ADDENDUM #5 – MARCH 4, 2024

RE: NORTH BAY FIRE STATION
Seismic Upgrade and Addition
Project #21.59

- **REVISED Sheet S2.1 Structural – Roof Framing Plan**
- **REVISED Sheet S7.2 Structural – Wood Framing Detail**

ROOF FRAMING PLAN

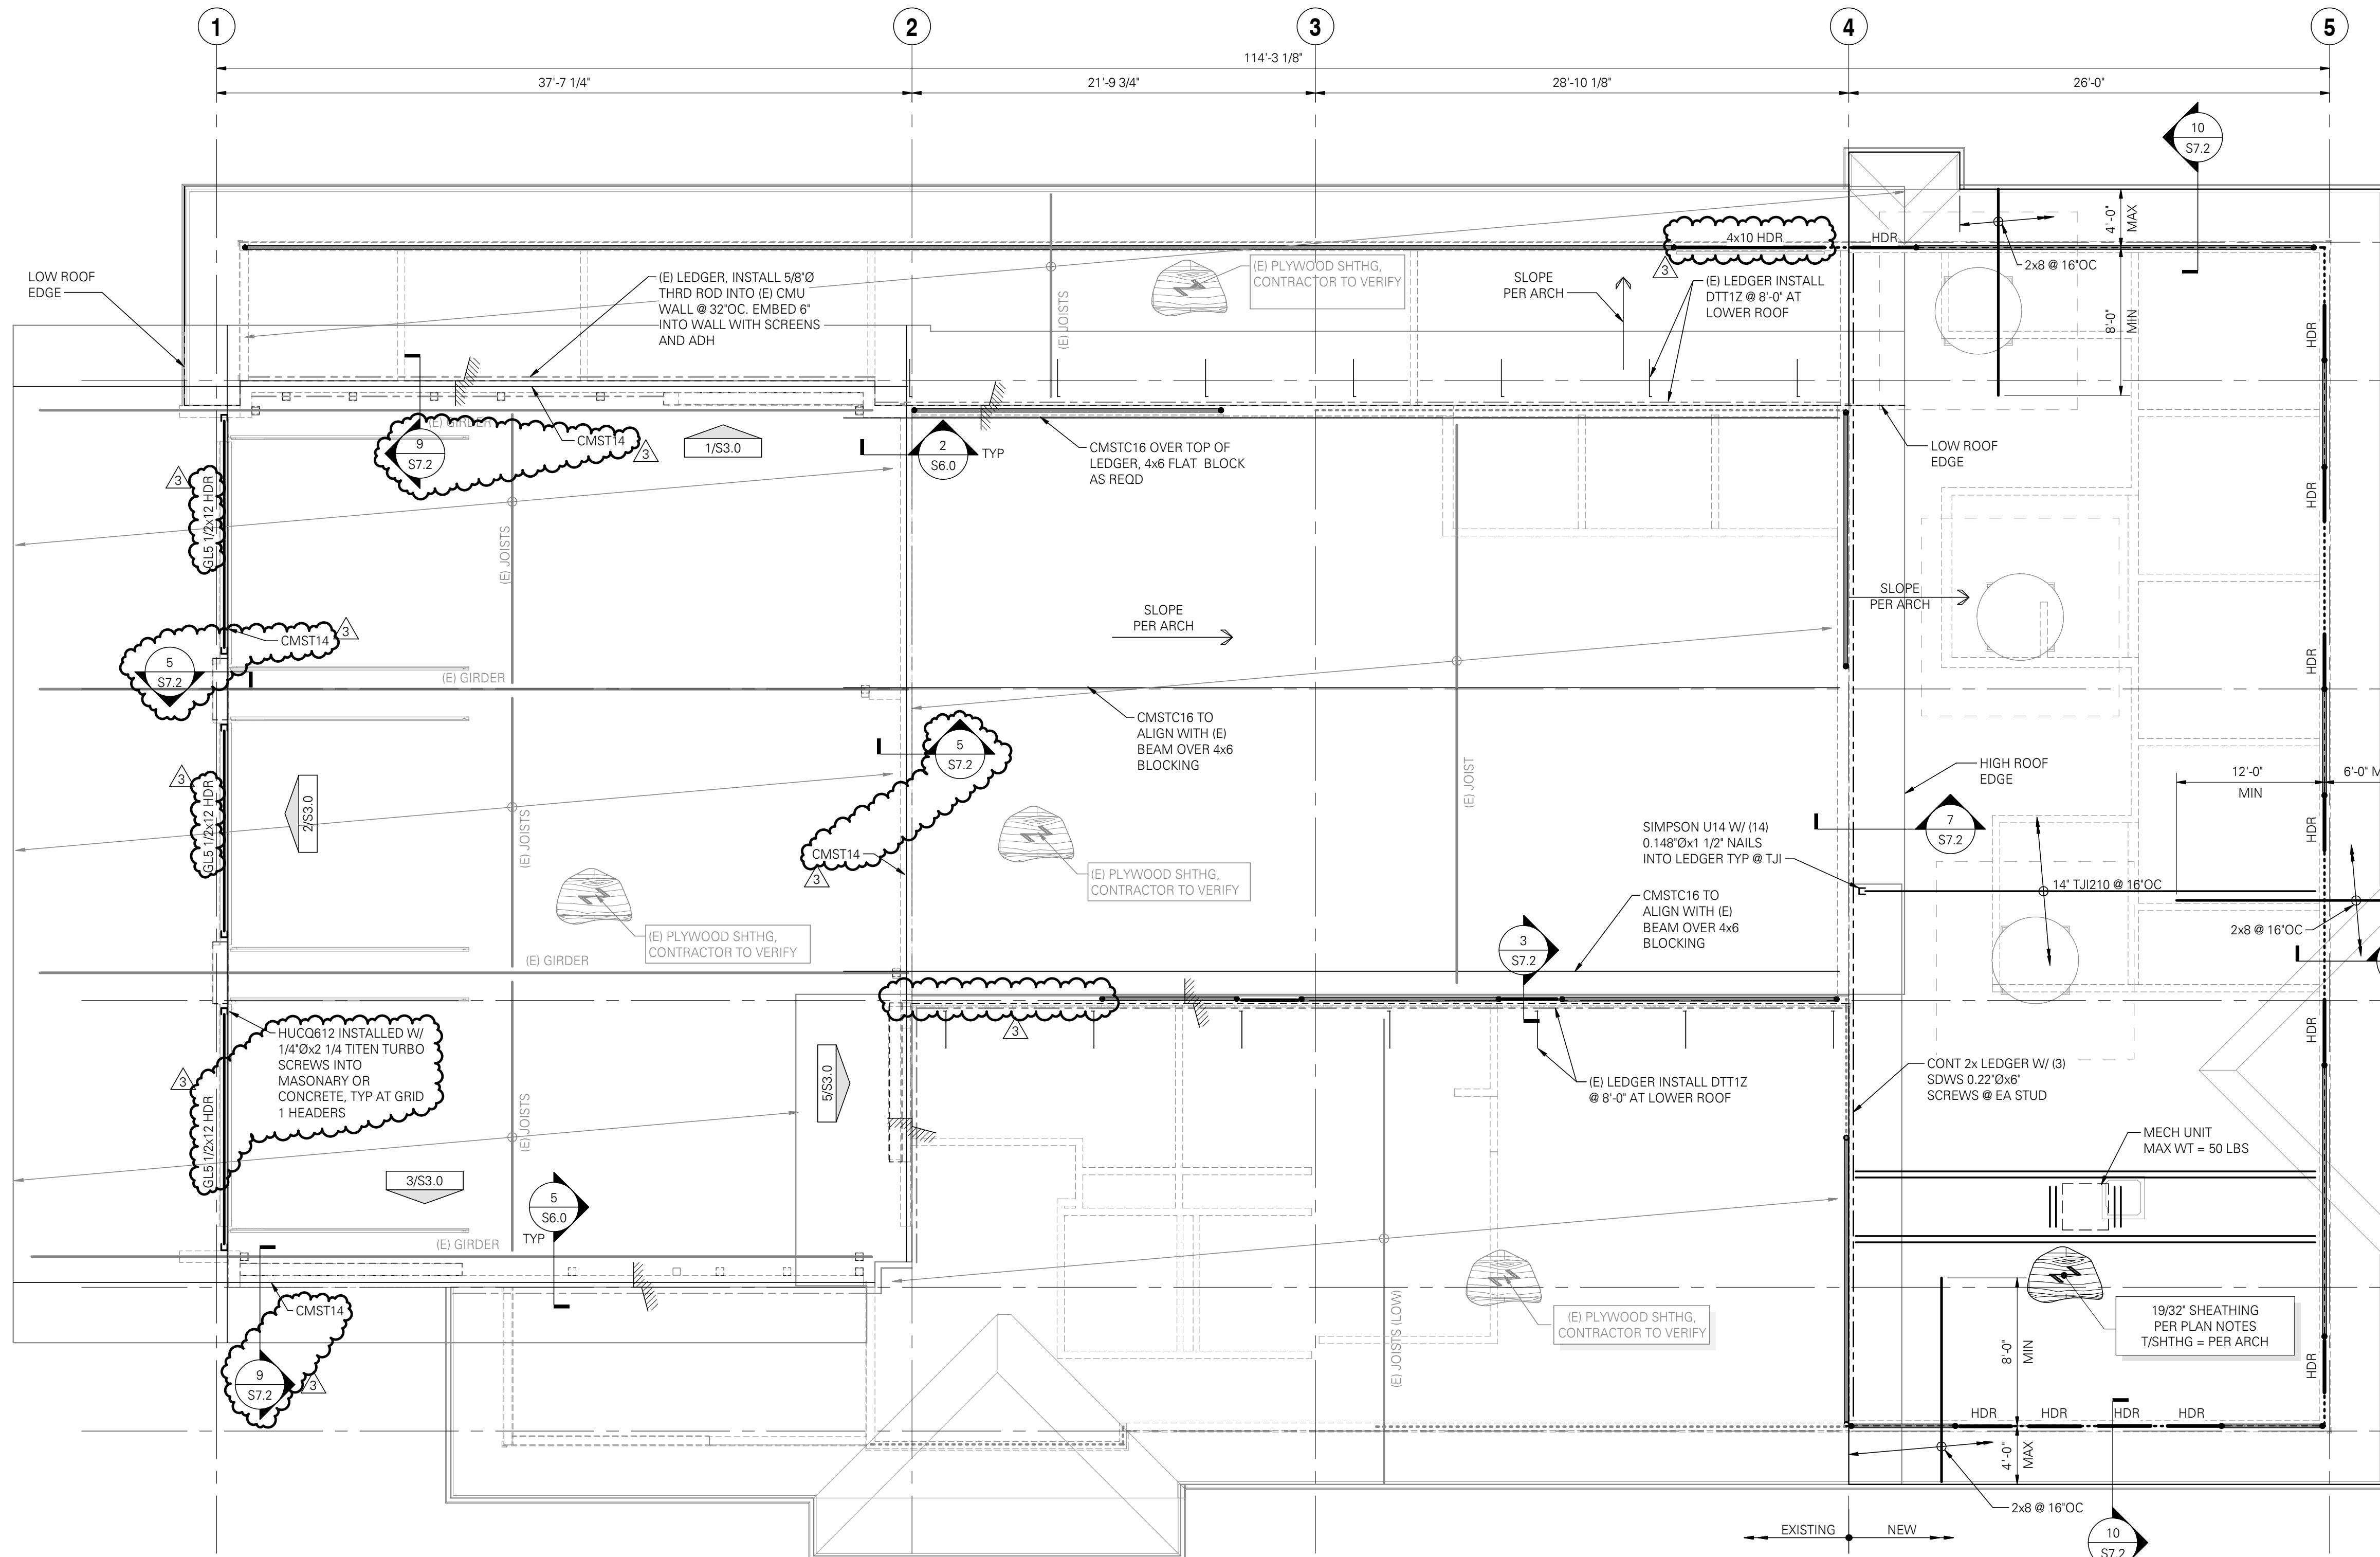
1. **Sheet S2.1, Footing at Grid 1:** Make the following notes:
 - a. A cold joint is acceptable for a 2-pour installation. Contractor to submit a joint location for review prior to construction.
 - b. See attached structural sheets S2.2 and S7.2 with added information for top of wall to roof connection.
